Maelor Foods, Pickhill Lane, Cross Lanes, Wrexham

Variation of Condition 07 of planning permission

APP/H6955/A/18/3216187 (P/2017/1032) to permit the processing of 2,000,000 birds per week

Response to Wrexham Council Highways Comments

Alternative Design Swept Path Analysis
16.5 Articulated Vehicle

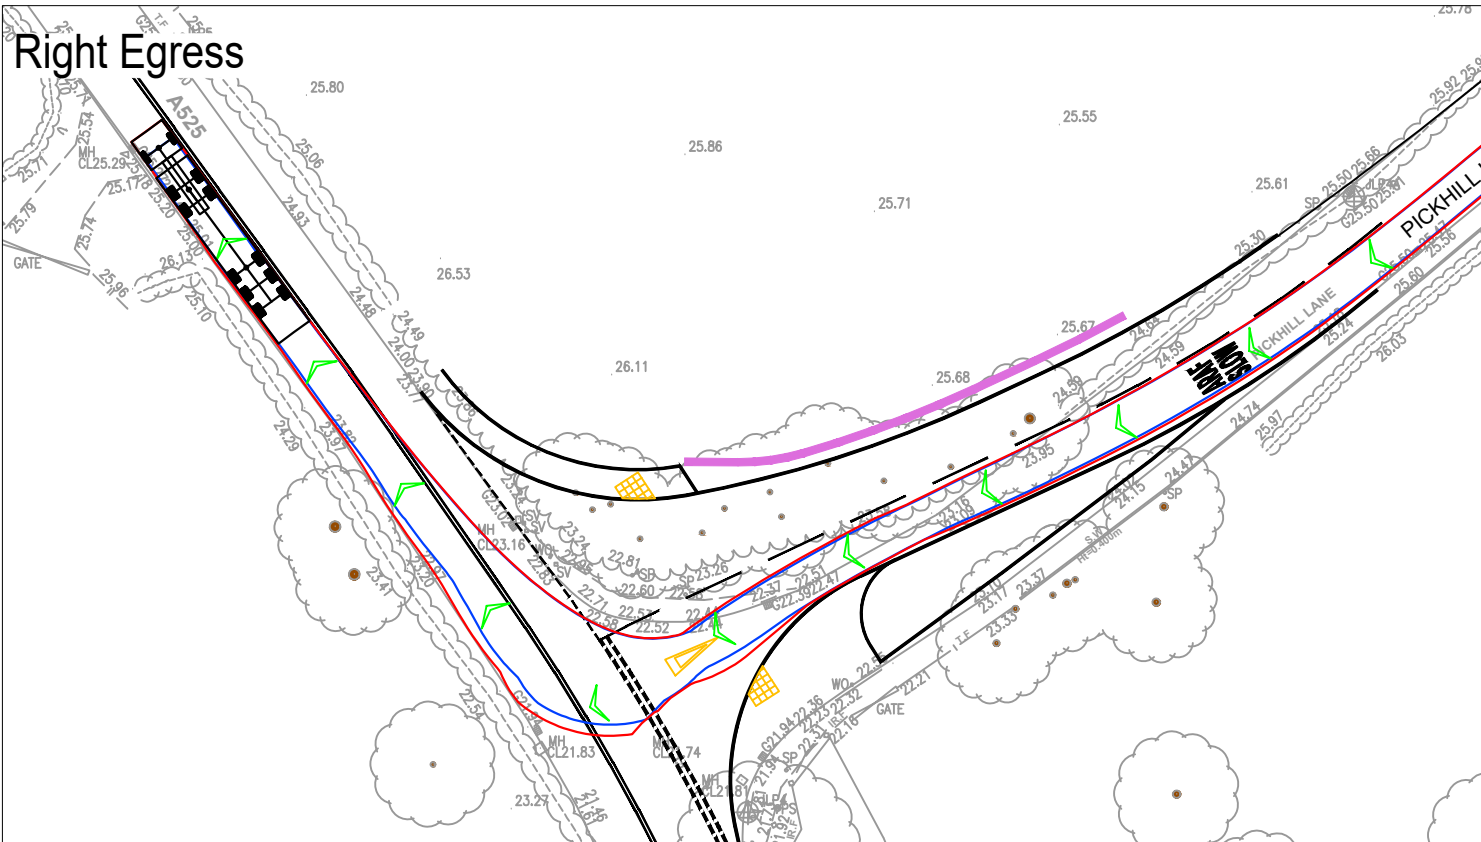
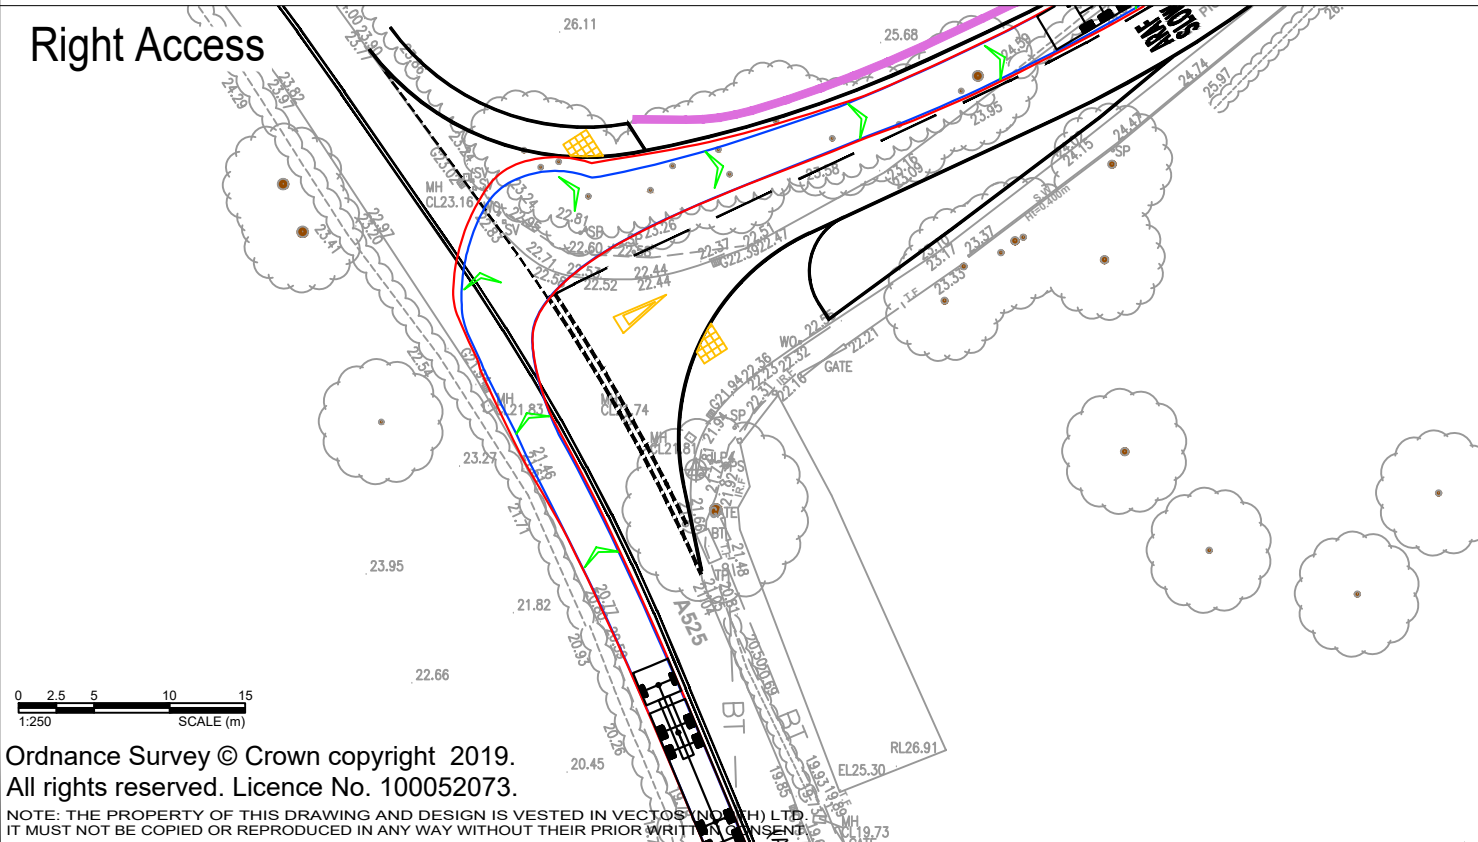
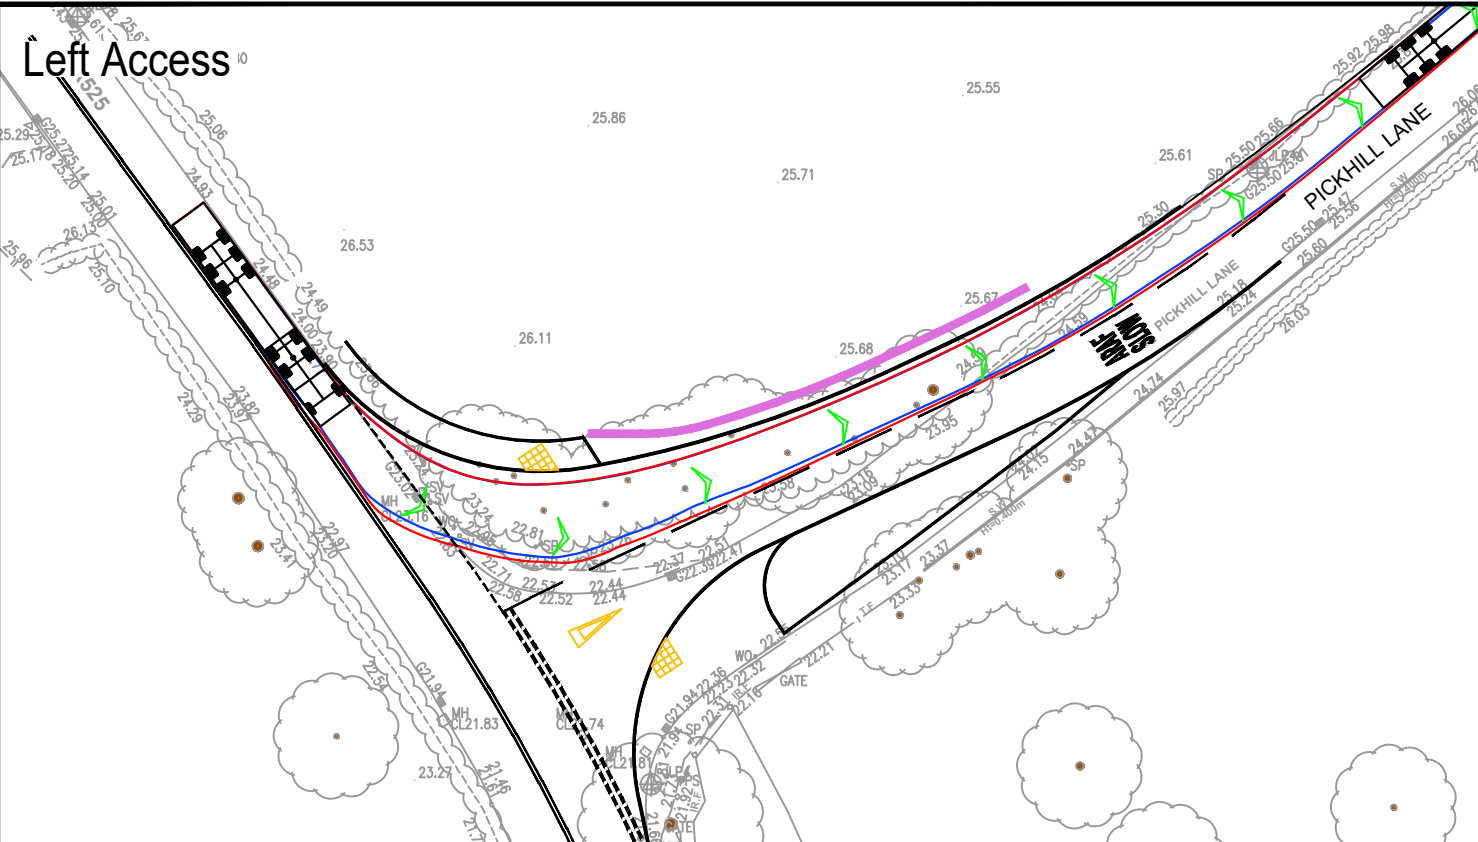
It is noted from reviewing the vehicle swept path drawings provided by the applicant, that right turn movements in and out of Pickhill Lane are still tight and that HGVs cross the centreline and run over the verge on A525 to undertake the movement. A vehicle swept path of the existing layout should be provided for a comparison of the two arrangements.

36. The vehicle tracking presented allowed ensured that the wheels and axles of the vehicles were within the carriageway extents with some flexibility for the vehicle body to overhang certain sections of verge (i.e. the rear of the trailer, if required).
37. To assist, the swept path analysis has been revisited to show the extents of the vehicle tracking with no body overhang of the verge. The updated tracking is presented in Vectos **Drawing VN22230-TR100 Rev A** attached to the rear of this report, and it has been subject to the Stage 1 Road Safety Audit, discussed further below.

Appendix C Problem Location Plan

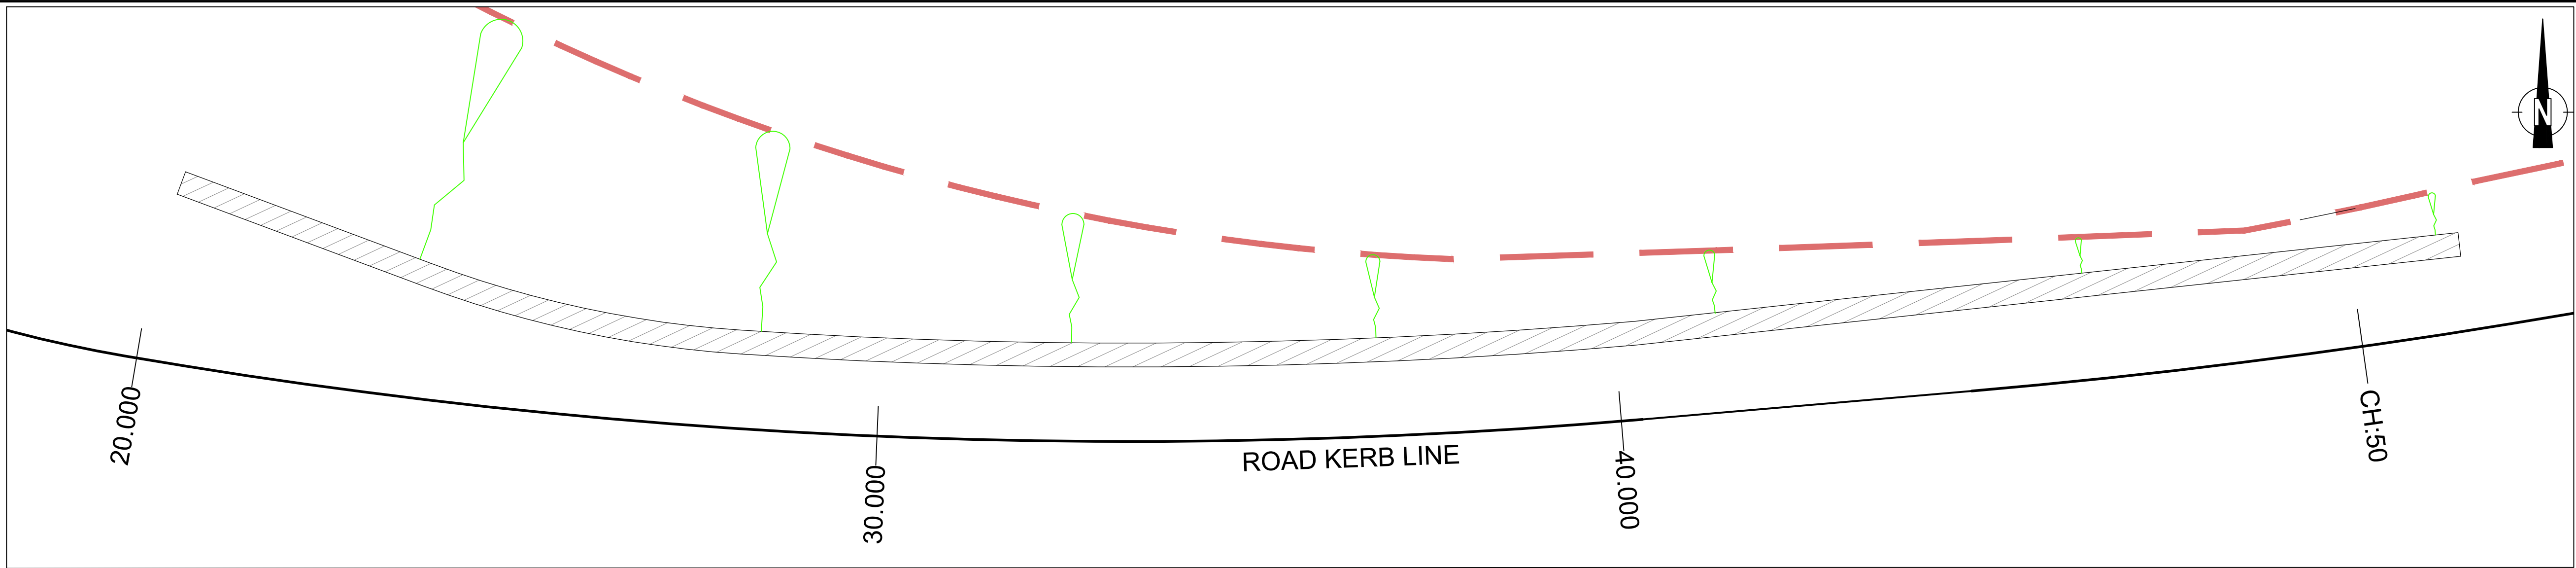
The widened junction arrangement requires that the Pickhill Lane approach 'sweeps' to the right, where the carriageway also has a fall towards the give-way line. Vehicles approaching at speed may lose control due to the combination of horizontal and vertical alignments. This may result in vehicles overturning or collisions.	
Recommendation	Provide increased grip surfacing on the approach to the junction.

Problem 6	
Location	East of junction
Summary	Change of alignment near crest of hill
 The alignment of Pickhill Lane will sweep to the right on approach to the amended junction. The change of alignment commences in the vicinity of a crest in the carriageway. This may cause drivers not to appreciate the bend and may result in collisions with the kerb, especially in dark conditions.	
Recommendation	Provide conspicuous feature on northern side to highlight the new kerb alignment.

Problem 8	
Location	East of junction
Summary	SLOW markings obscured
ARAF/SLOW road markings are to replace the existing road markings, c.45 metres in advance of the give-way line. These are in the vicinity of the crest in the carriageway and may not be seen by drivers. This may result in vehicles overshooting the junction.	
Recommendation	Ensure ARAF/SLOW road markings are visible and at appropriate distance in advance of the give-way line. Also see Problem 5.

Problem 4: Vehicle stability due to combination of bend and downhill slope (Pickhill Lane)	Provide increased grip surfacing on the approach to the junction.	Accepted. The curves and gradients on Pickhill Lane are existing conditions that have previously accommodated regular HGV movements, with slow approach speeds, and no recorded accidents. However, as per the recommendation, increased grip surfacing will be provided on approach to the junction on Pickhill Lane, with further consideration to be given during detailed design.		
Problem 5: Various downhill gradients approaching the junction (Pickhill Lane)	Provide consistent gradient on approach to the junction.	Accepted. The gradients on Pickhill Lane are existing conditions that have previously accommodated regular HGV movements, with slow approach speeds, and no recorded accidents. However, as part of the detailed design consideration can be given to providing a more consistent gradient where possible, subject to existing levels constraints associated with adjacent access points and the A525 carriageway. Supplementary warning signage on approach is already provided.

Problem 6: Change of alignment near crest of hill (Pickhill Lane)	Provide conspicuous feature on northern side to highlight the new kerb alignment.	Accepted. For information, the centre line radius of the curve on approach to the junction is 100m which is in excess of the minimum recommended curve radius of 64m for a 60kph/37.5mph design speed referenced in MfS2, which is to be read in conjunction with TAN18. Combined with the review of gradients and surfacing (as noted in Problem 6 and 7), a conspicuous feature can be provided to highlight the new kerb alignment. A further review will be undertaken during detailed design.		
--	---	--	--	--
